Product/Process Change Notice (PCN)

PCN Number: PCN_PeRATR_20250911

Affected Series: WP-RATR

Before Change (only 7461103)

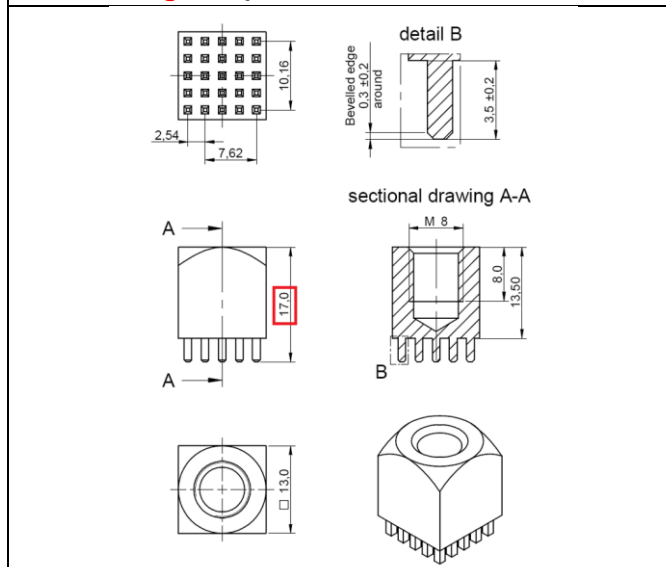
Dimension in the drawing without bracket:

17.0

After Change (only 7461103)

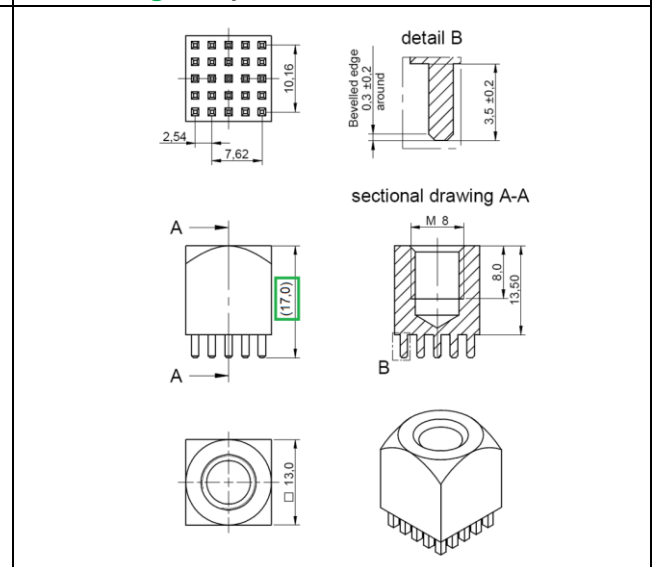
Dimension in the drawing with bracket:

(17.0)
